WESTERN REFINING - GALLUP REFINERY SANITARY WASTEWATER COLLECTION

**RE: NOTICE OF DISAPPROVAL
PROCESS DESIGN REPORT FOR THE WASTEWATER TREATMENT
PLANT WORK PLAN (ALTERNATIVE DESIGN)
WESTERN REFINING COMPANY, SOUTHWEST INC., GALLUP REFINERY
EPA ID # NMD000333211
HWB-GRCC-09-006**

The New Mexico Environment Department (NMED) has completed its review of the *Process Design Report for the Wastewater Treatment Plant Work Plan (Alternative Design)* (Work Plan), dated September 2009, submitted on behalf of Western Refining Company, Southwest Inc., Gallup Refinery (the Permittee). The Permittee must provide additional information before NMED can complete its technical review. NMED hereby issues this Notice of Disapproval (NOD).

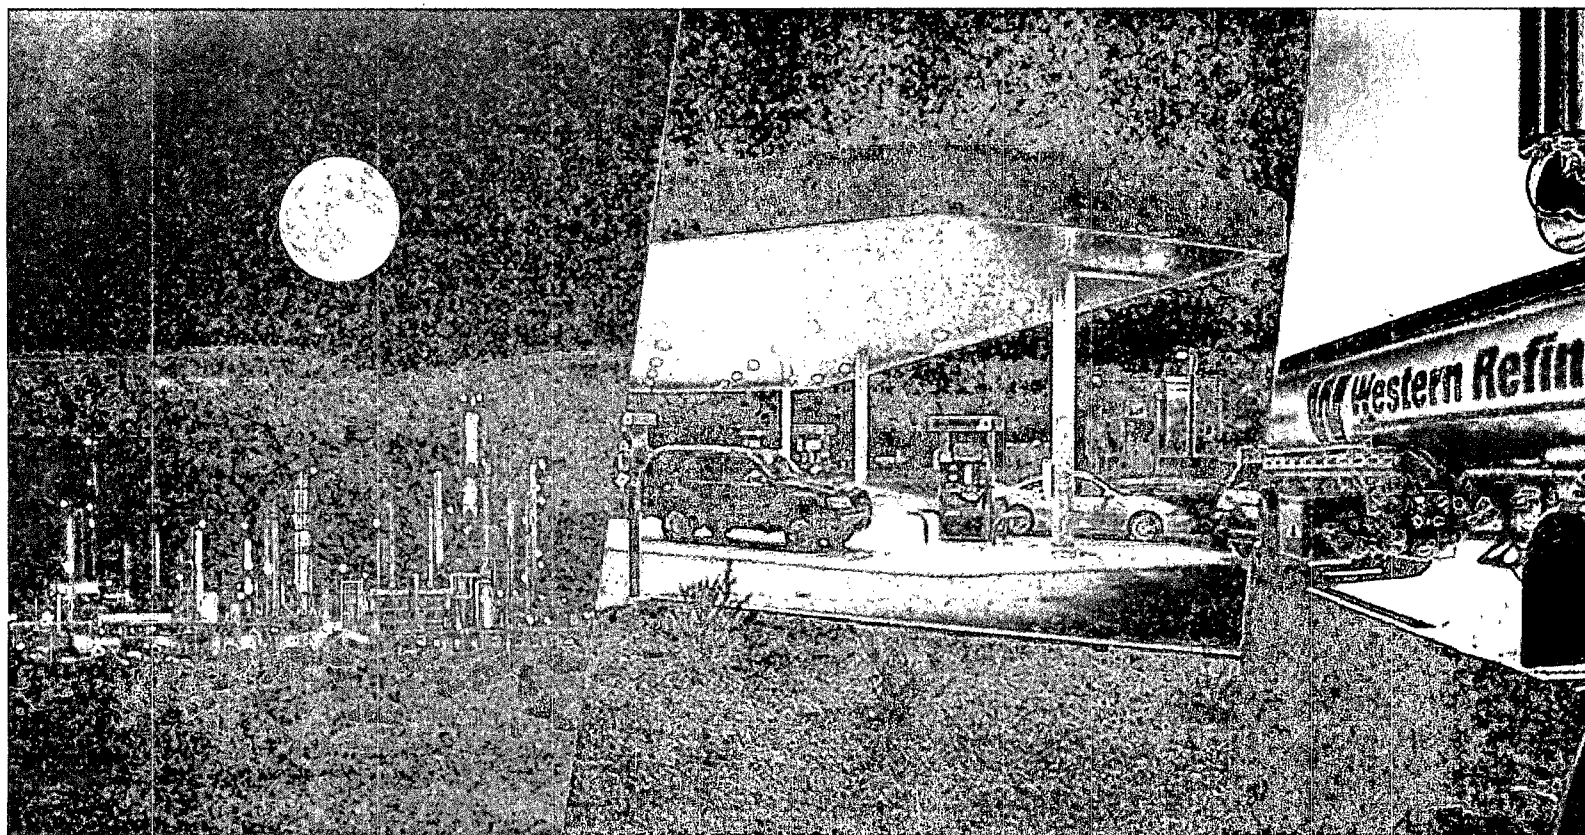
The Permittee included a flow diagram of the alternative design to the WWTS in Figure 1 Flow Diagram Alternative WWTP UPGRADE (attached). The Permittee must revise the figure and add additional figures as necessary to address the following in the revised Work Plan.

- a. The Legend found in Figure 1 defines dashed lines as existing; the figure has the API separator surrounded by dashed lines because it is an existing structure. In the response letter, the Permittee must explain why the Storm Water Tanks T27 and T28 were not surrounded by dashed lines since these also are existing structures. The Permittee must revise the figure accordingly.

- b. The figure(s) must be design drawings of the actual WWTS that will be installed. The drawings must include the exact number of tanks that make up each component of the WWTS, piping, secondary containment, and leak detection. The drawing must also depict exactly where the flows will be entering and exiting through the various WWTS units (e.g., will influent enter at the top of tanks, sides).

- c. The flow diagram must present all above and underground piping associated with the WWTS.
- d. NMED requires additional flow meters. The locations of the flow meters are shown on the Attached Figure 1.

Figure 2. MPPE Process Schematic
(courtesy of Veolia Water)

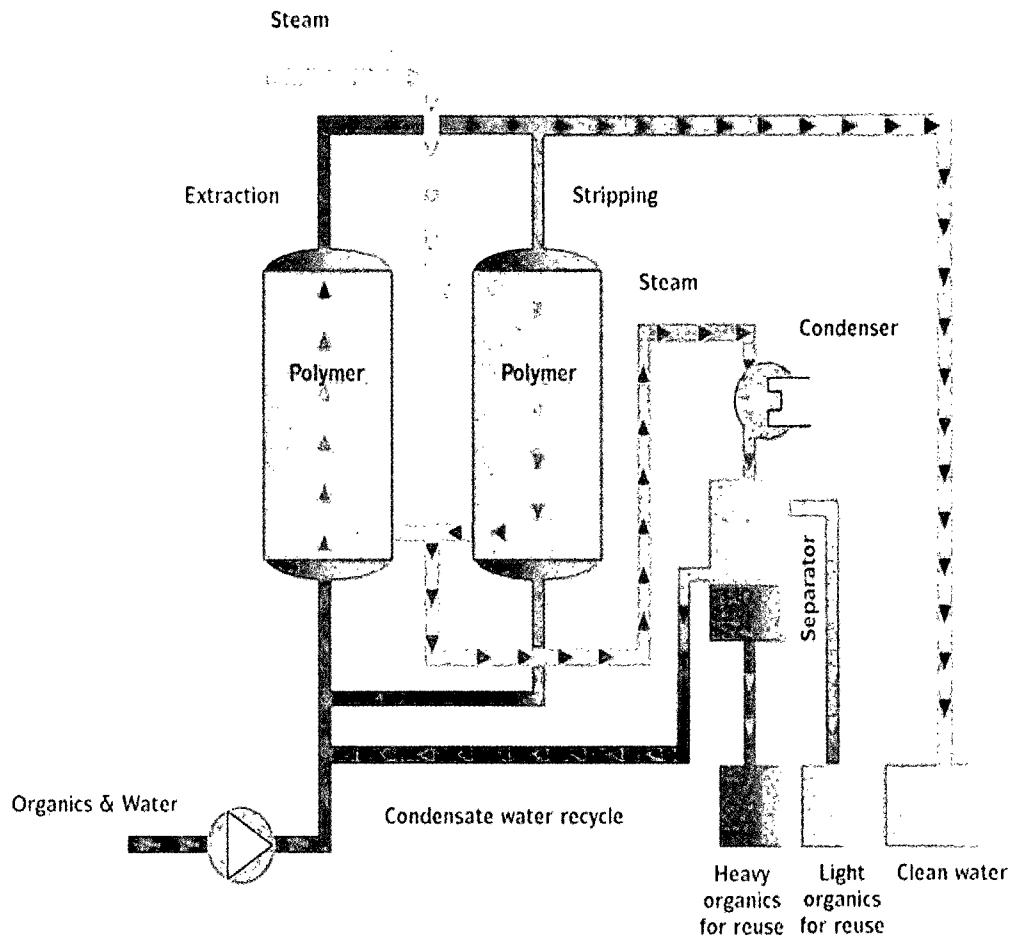
In Section 3.3 (Macro Porous Polymer Extraction Technology), page 6, the Permittee states "[a] schematic of the MPPE process is provided in Figure 2."

The schematic diagram shown in Figure 2 is a generic schematic diagram from the manufacturer, which was also shown in Attachment B. The Permittee must revise Figure 2 of the Work Plan to include the design drawing of Macro Porous Polymer Extraction (MPPE) Technology that will actually be installed at the facility, in addition to all design details.
